Doc. No.:	SB035
Revision:	00
Rev. Date:	03/07/2025

# **SERVICE BULLETIN 35 – Wiring connector verification**

Wiring connector verification and rectification (if needed) of the part number SS406J, which is part of the cables SS461.

Figure 1: Mate-N-Lok 3x3 way connector; wrong vs correct insertions

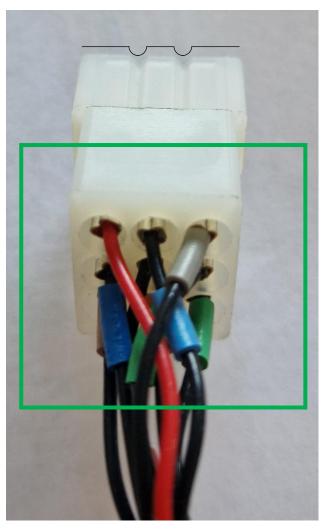
During the verification of the wiring production in I.C.P., a connector was found to be assembled with the wrong order of wirings. The wrong sequence can not produce any damage to the airplane systems, instruments or avionics, but can lead to a not correct function of the engine instruments. It is anyway suggested to not install the affected wiring or switch on the master battery (or even connect the battery positive pole) before the cable SS406J has been verified.

**WRONG INSERTION SEQUENCE**

- Identify the affected wiring SS406J and connector, as shown in Figure 2;
- Verify the sequence of wires insertion in the connector, as shown in Figure 1. Follows in Table 2 the correct sequence of wires insertion;

- If the wires sequence has been found installed correctly, the Service Bulletin is considered complete, no need of other action;
- If the wires sequence is not correct, disassembly all the pins with the tools highlighted in Ch. 8;
- Then, re-install the pins with the correct sequence, as shown in the right side of Figure 1 and Table 2;
